Building Manager: [Brian Keith Jensen, bjensen@engr.orst.edu](mailto:bjensen@engr.orst.edu)  
 Assessment Date: 9/6/2022  
 Assessment Number: **10598**  
 Location: Dearborn Hall Entire  
 Reinspection date:

A joint fire safety inspection of the facility listed above was performed by the Environmental Health & Safety - Fire and Life Safety and the Corvallis Fire Department. These fire safety deficiencies could result in a fire or jeopardize the safety of those occupying the facility. Please see that these items are corrected immediately and no later than the scheduled reinspection date noted with this report. If you have any questions regarding this inspection, please email Brian Lilley (EH&S - Fire and Life Safety) at [brian.lilley@oregonstate.edu](mailto:brian.lilley@oregonstate.edu).

Room 1E

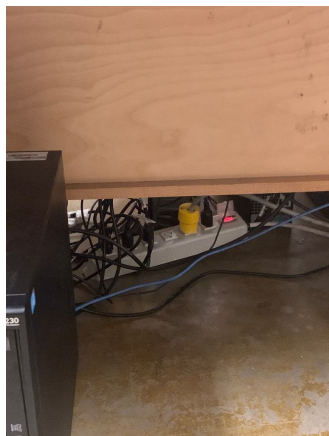
<b>Priority code</b>	<b>Standard in need of attention</b>	<b>Reg.Reference</b>	<b>Location</b>	<b>Resp</b>	<b>Observations &amp; Recommendations</b>	<b><a href="#">Date Corrected</a></b>
2	Approved covers shall be provided for all switch and electrical outlet boxes.	2019 OFC 604.6	0001E:inside on wall	FS	Replace j-box cover plate in room 1E.
